07/30/14	Revise detail
Date	Revision
STATE OF HAWAII DEPARTMENT OF TRANSPORTATION HIGHWAYS DIVISION	
DRAINAGE DETAILS	
PHASE 1 - KAUMUALII HIGHWAY LIHUE MILL BRIDGE TO RICE STREET PHASE 2 - NAWILIWILI STREAM BRIDGE AND MAUKA WIDENING	
Scale: As Shown	Date: March 25, 2013
SHEET No. C-50 OF 84 SHEETS

Date	Revision
07/30/14	Revise drain outlet plan and profile. Add note.
DEPARTMENT OF TRANSPORTATION HIGHWAYS DIVISION	
DRAINAGE DETAILS	
PHASE 1 - KAUMUALII HIGHWAY LIHUE MILL BRIDGE TO RICE STREET PHASE 2 - NAWILIWILI STREAM BRIDGE AND MAUKA WIDENING	
Scale: As Shown	Date: March 25, 2013
SHEET No. C-51 OF 84 SHEETS

SHEET No. C-52 OF 84 SHEETS

"AS-BUILT"

Grass Swale Detail
Not to Scale

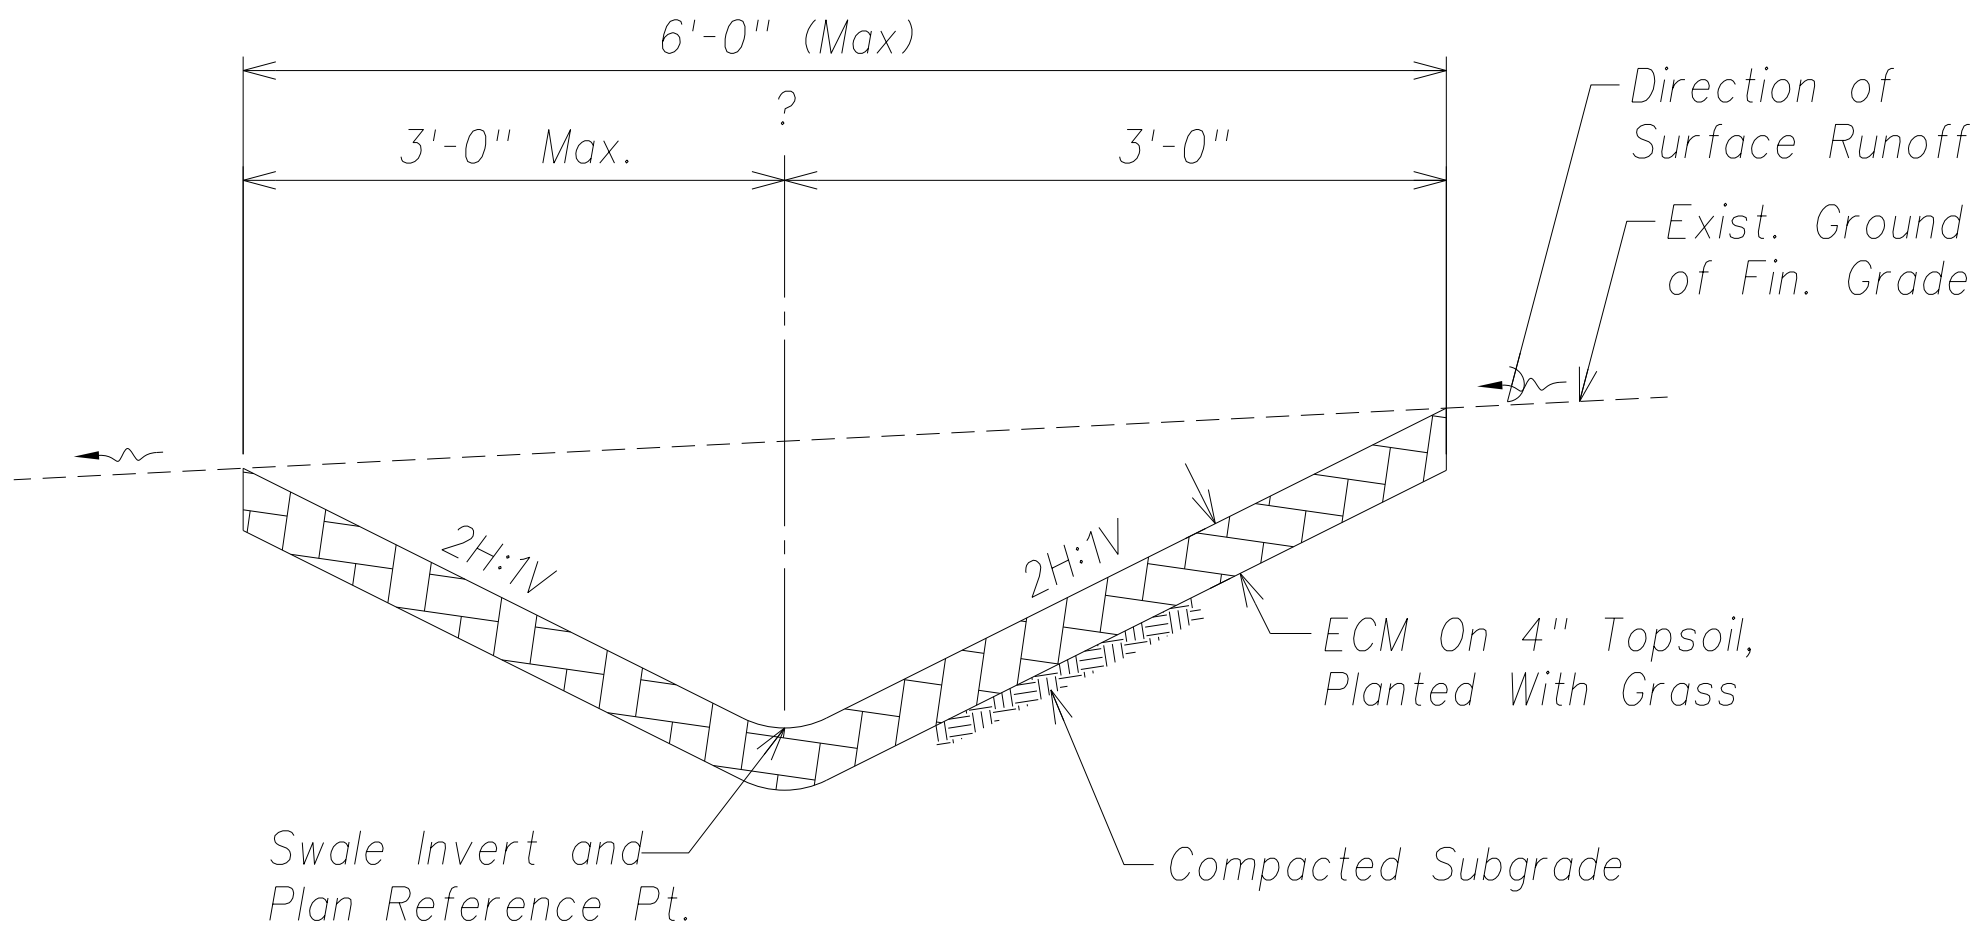
RFI-D NO. 45
REMOVE AGGREGATE
SUBBASE

Section  
Scale: 1/2"=1'-0"

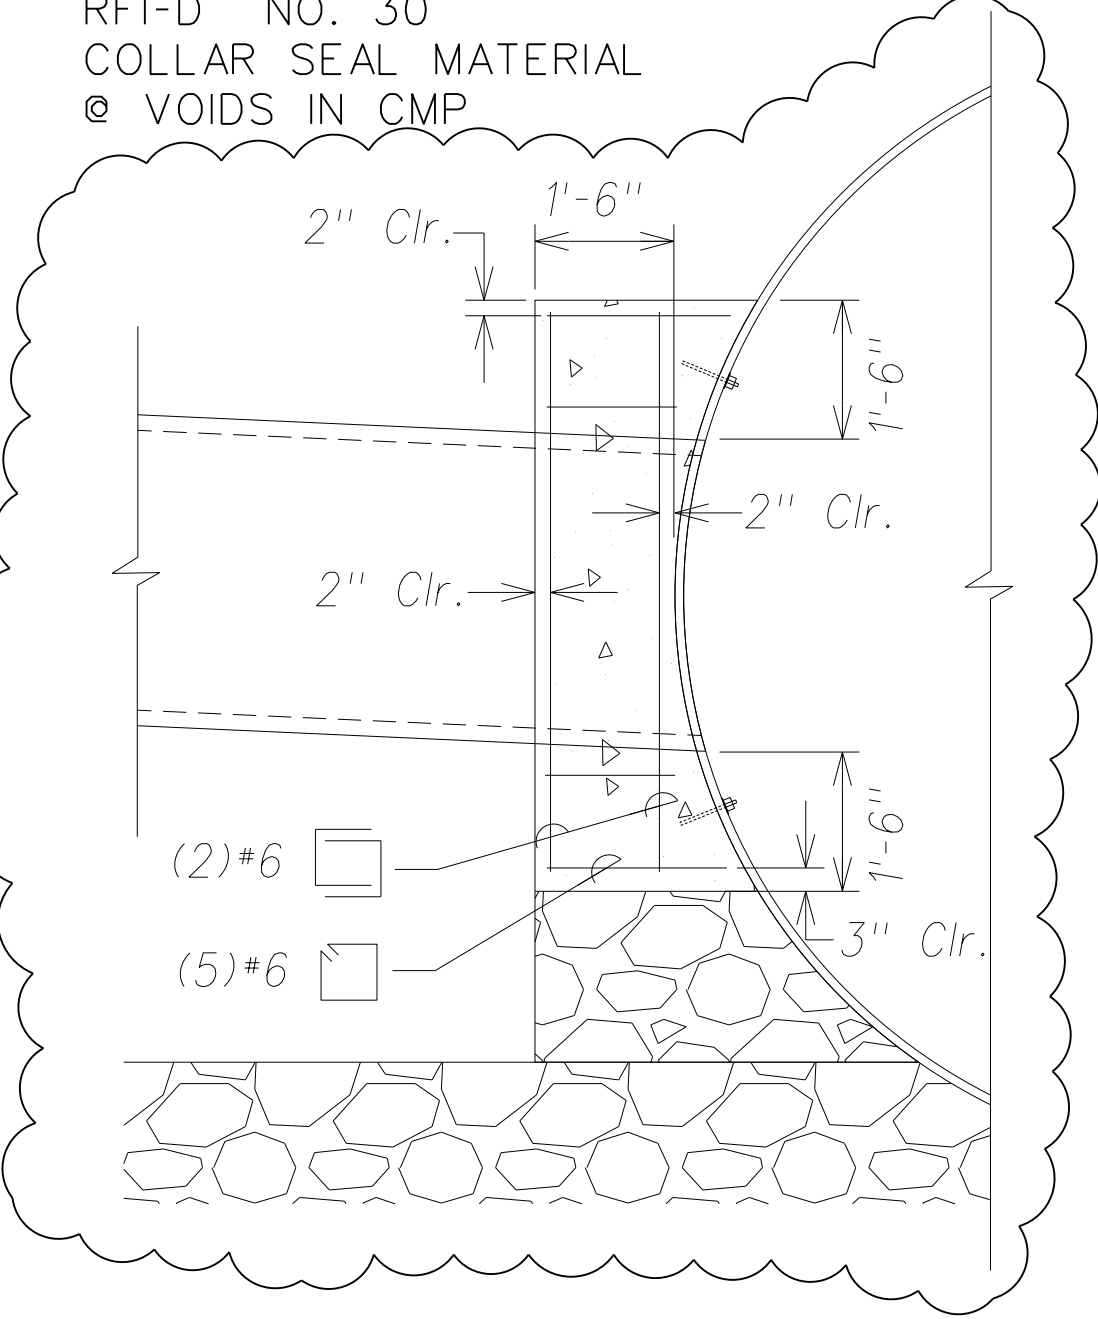
RFI-D NO. 30  
COLLAR SEAL MATERIAL  
@ VOIDS IN CMP
